**TOWN PLAN AND ZONING COMMISSION  
GLASTONBURY, CT  
APPLICATION FOR SPECIAL PERMIT**

**STAFF REPORT**

**Proposal:**  
Section 12 Special Permit with Design Review: Conversion of Residential Hom to Office with Addition

# Architectural & Site Design Review Committee Report

**SITE PLAN**  
**#148 OAK STREET**  
PREPARED FOR  
**DELPONTE PLUMBING**  
GLASTONBURY, CONN.

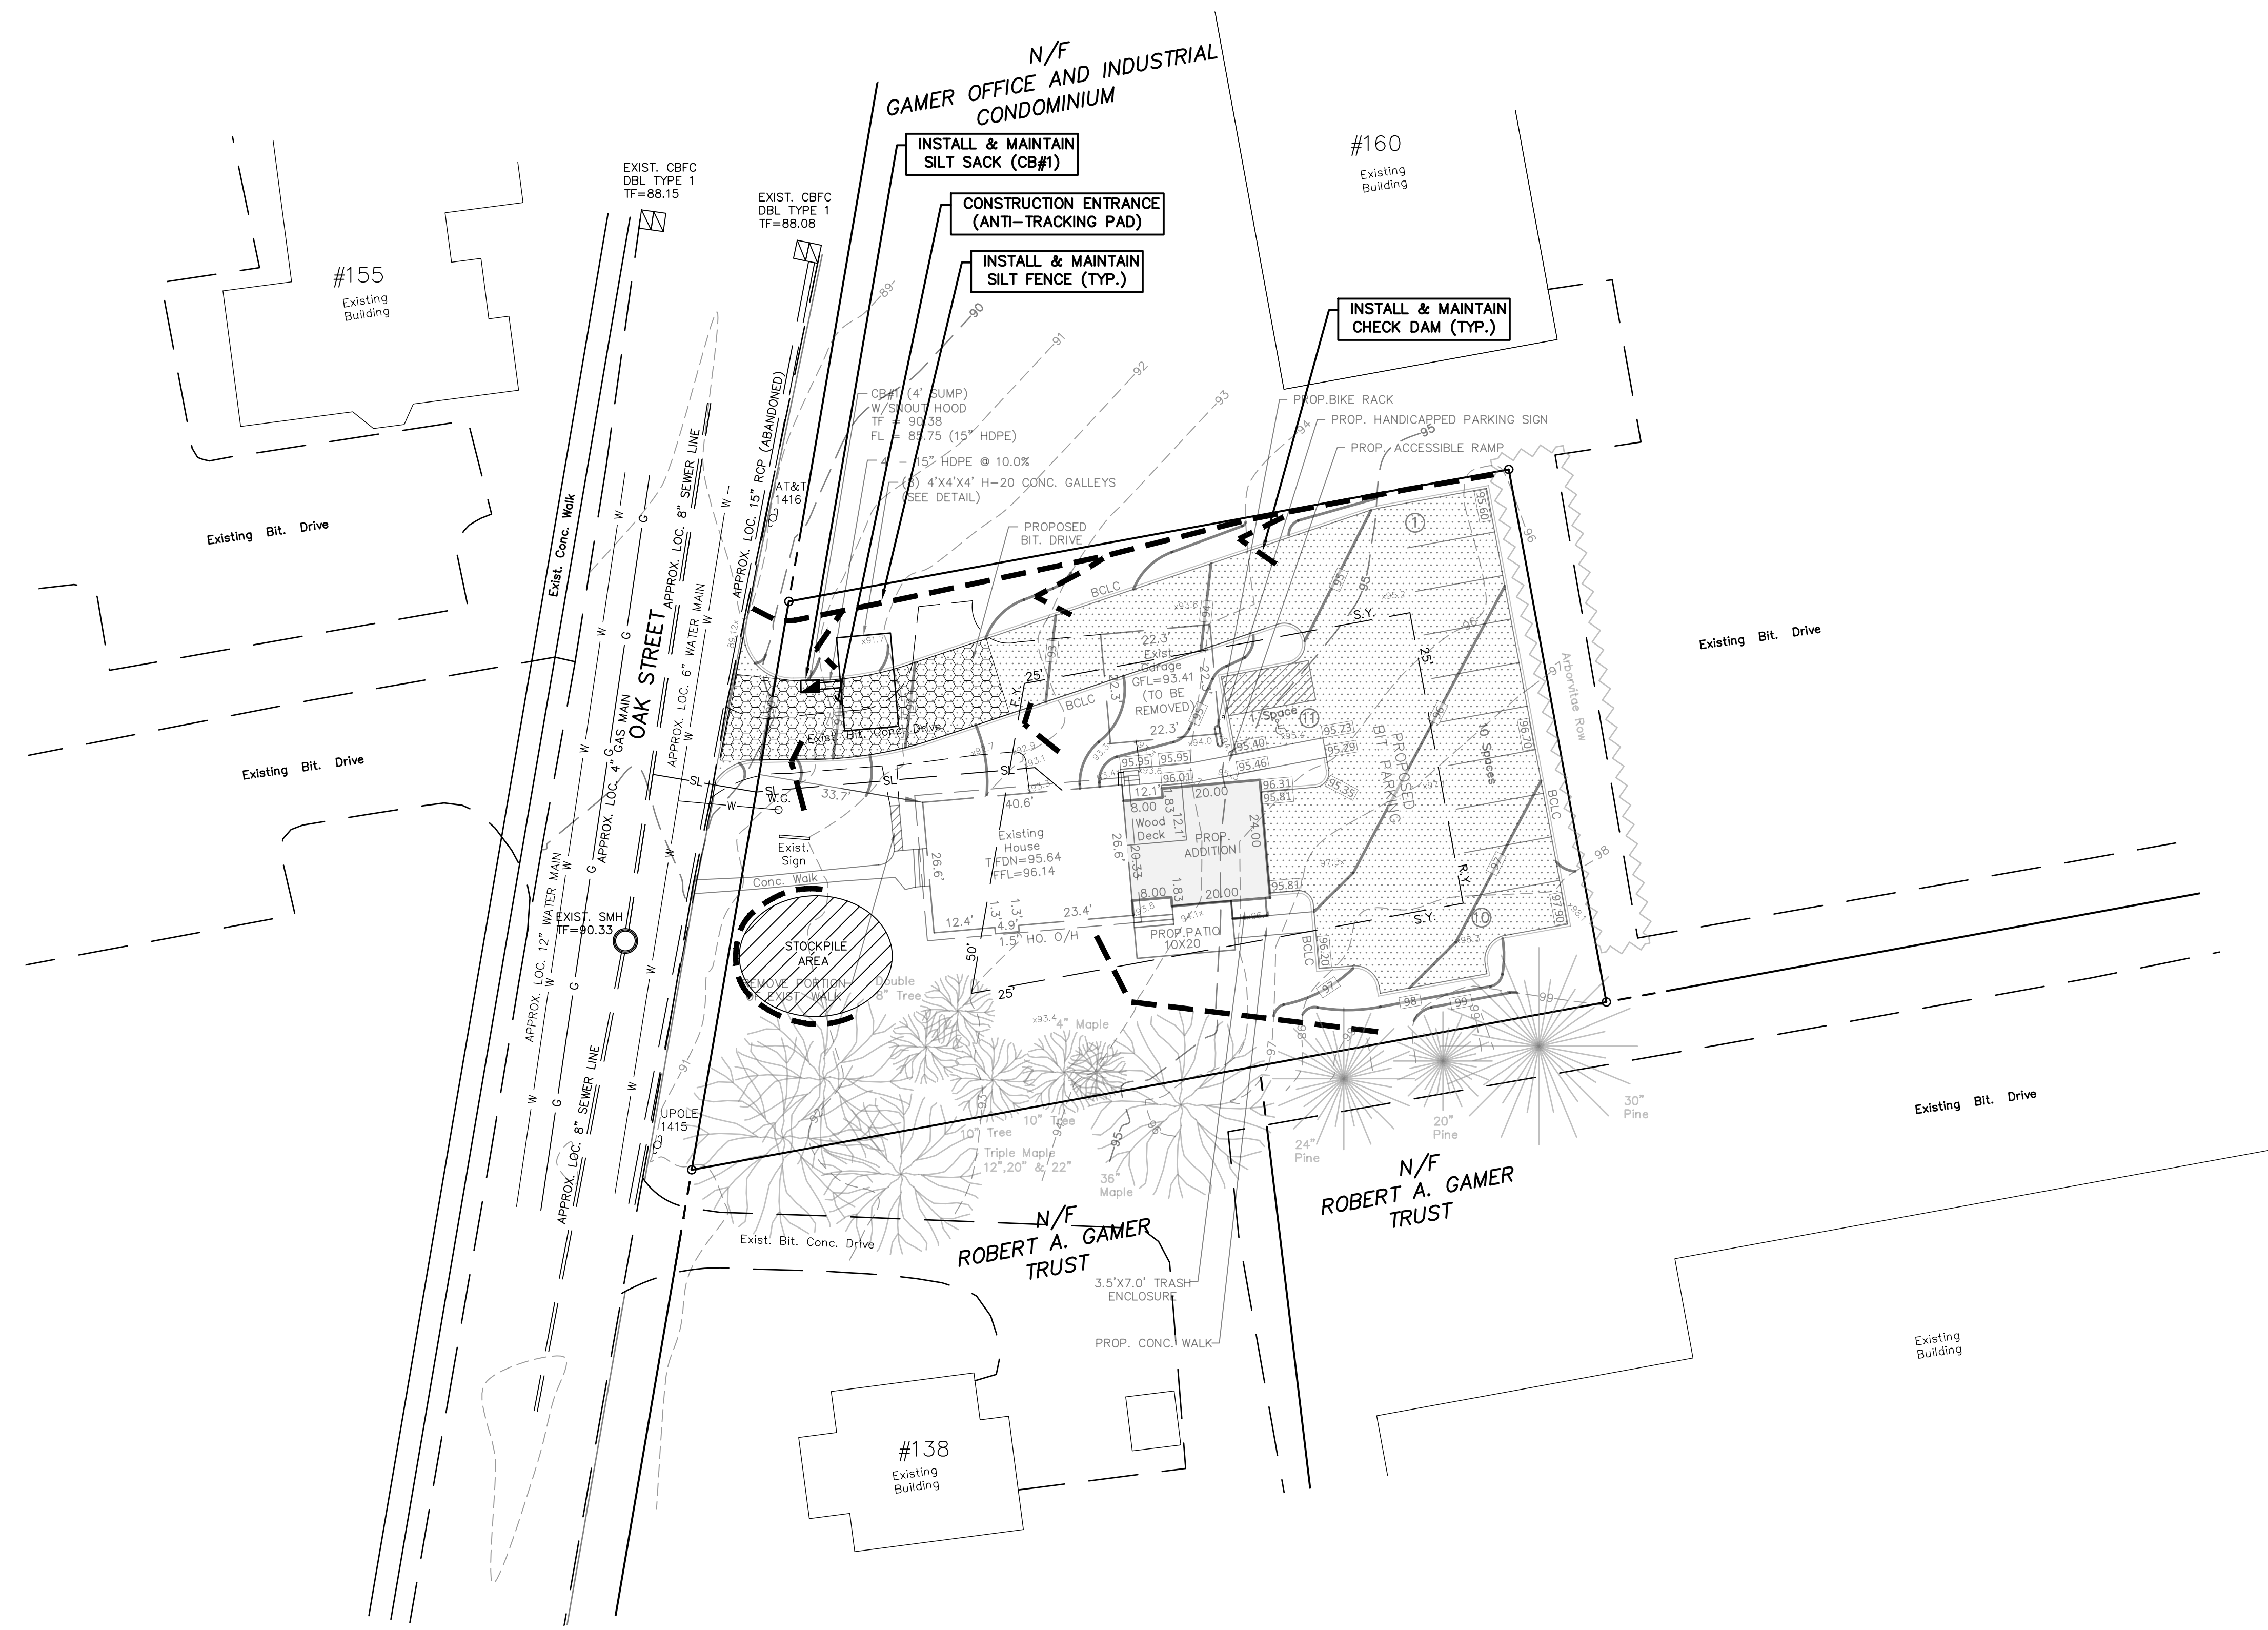
3. An MS4 tracking table needs to be provided on the plans summarizing the pre and post development impervious areas and directly connected impervious areas.

4. The stormwater maintenance program should be revised to include required maintenance of the proposed infiltration system and to indicate that the property owner is required to perform all such maintenance. This maintenance plan should also be relocated to the site plan for ease of future reference.

6. Proposed site lighting should be shown on the site plan and planting plan for coordination with other design elements. Appropriate details for proposed site lighting including foundations, luminaires, and mounting details should be included on the plans.

7. The Engineering Division standard inspection note should be added to the site plan.
8. Applicant shall provide a copy of final stamped and signed plans and computations in PDF form to the Town Engineer.

EROSION & SEDIMENTATION CONTROL PLAN  
**#148 OAK STREET**  
 PREPARED FOR  
**D'ELPONTE PLUMBING**  
 GLASTONBURY, CONN.

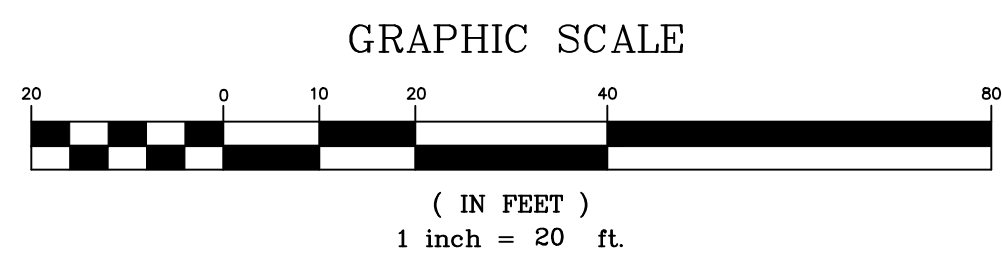
5. A silt sack is required for the closest catch basin in Oak Street downhill of the proposed driveway and should be indicated on the erosion and sediment control plan.

WATER QUALITY SYSTEM  
NOT TO SCALE

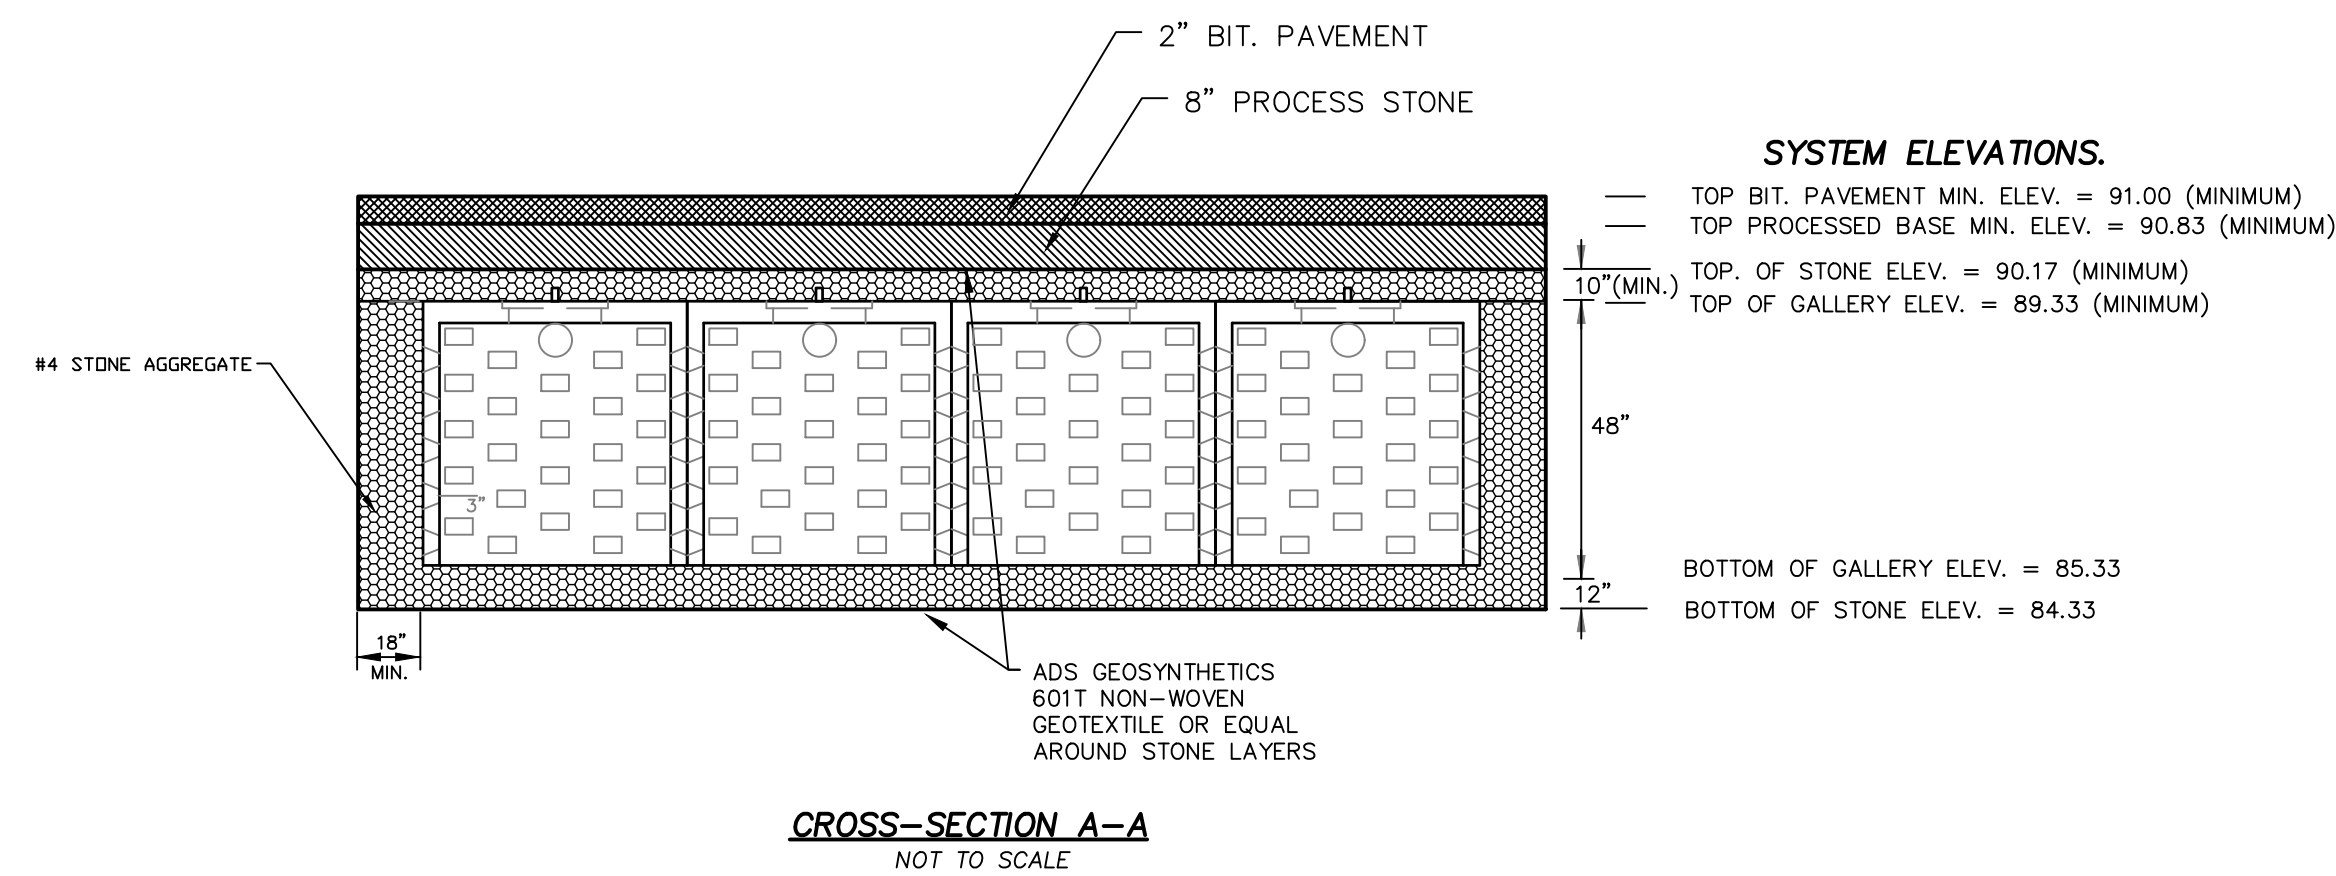
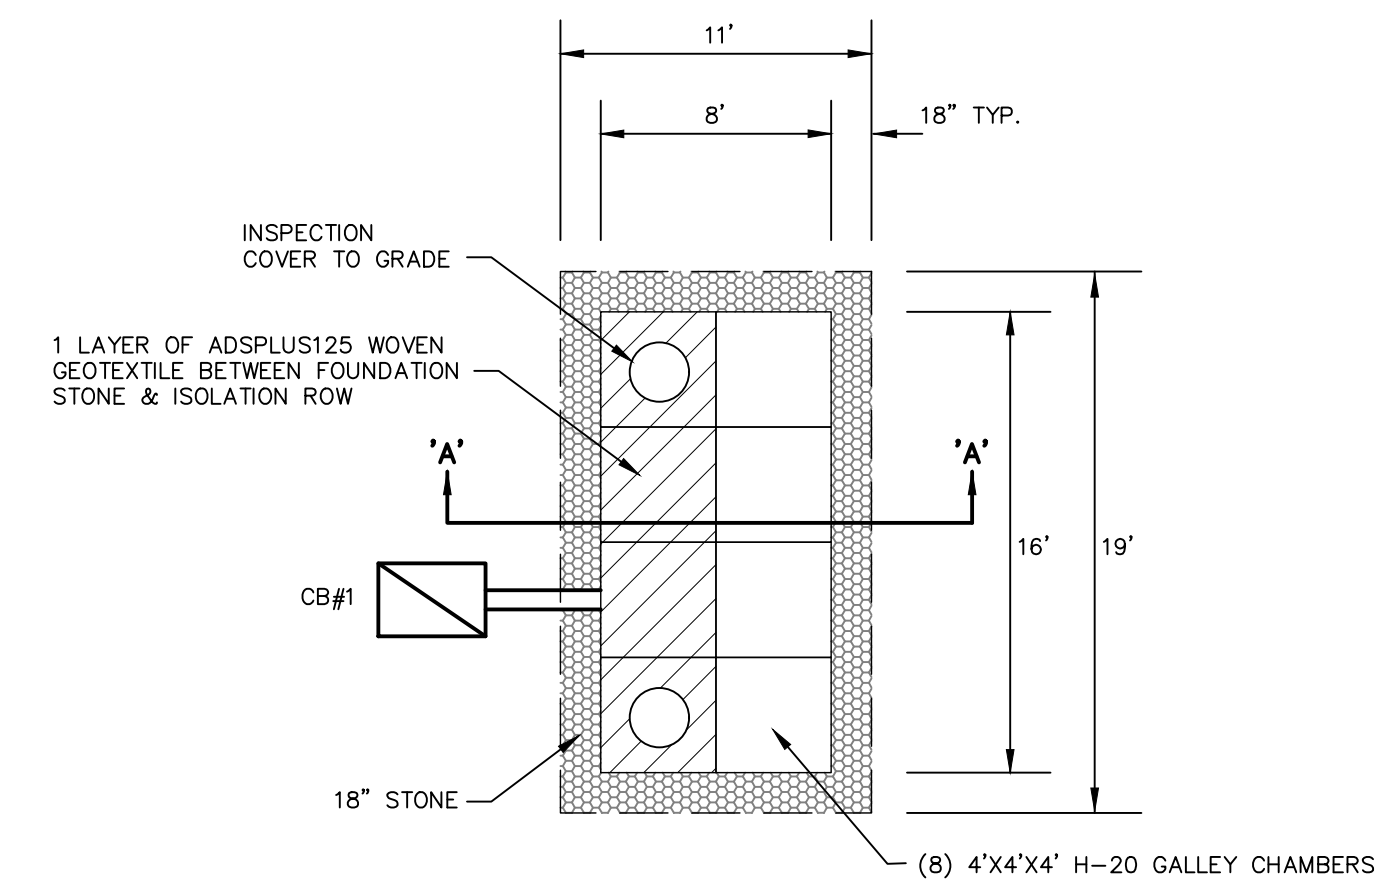
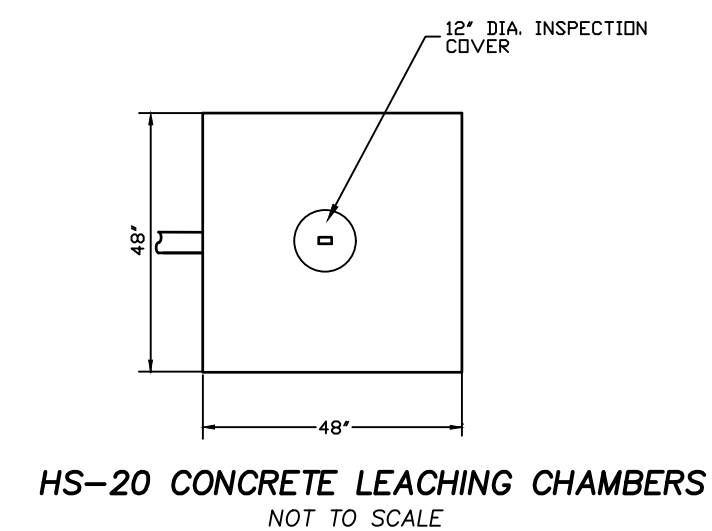
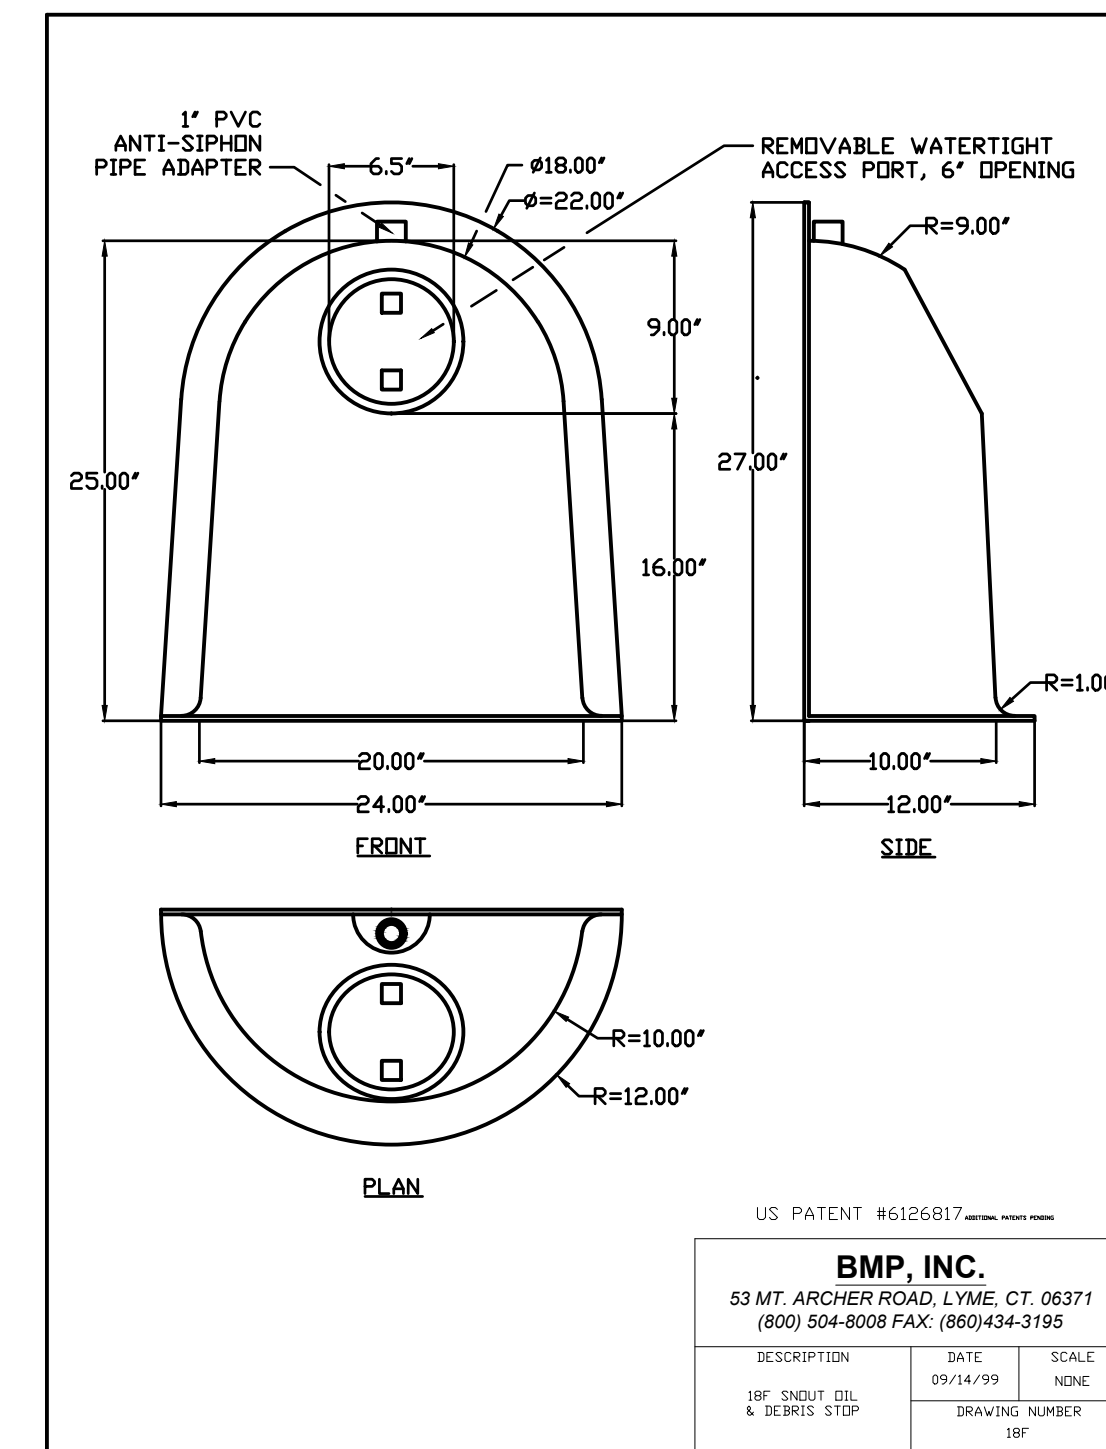
2. Water quality volume computations should be corrected to utilize the 1.3-inch run-off depth recommended by the 2023 DEEP Stormwater Quality Manual and to clarify that the required volume is achieved through a combination of static storage volume as well as infiltration volume.
